S E R V I C E N O T E

4396B Network/Spectrum Analyzer

Power Supply may fail due to it's design.

DATE: December 1997

4396B Replace A40 Pre-Regulator

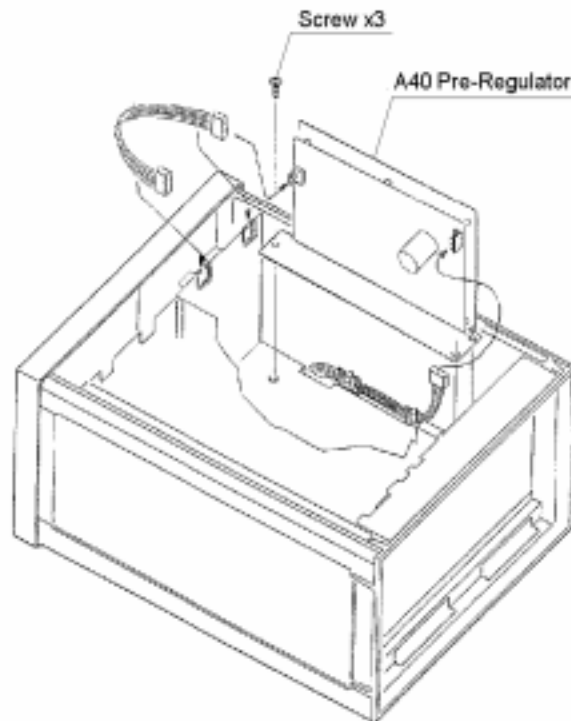
The Power Supply (A40 Pre-Regulator) may fail due to a problem in its design by a 3rd company. This problem most likely happens when the line switch is cycled on and off quickly while the unit is warm.

Replace the Power Supply according to the following procedure. Then execute the Internal Test for verification.

1. Remove the two feet located on the top of the rear panel.
2. Remove the top cover.
3. Remove the shield plate.

4. Disconnect the two connectors.
5. Remove the A40 Pre-Regulator.
6. Replace the new A40 Pre-Regulator.
7. Connect the two connectors.
8. Replace the shield plate, the top cover, and two feet.
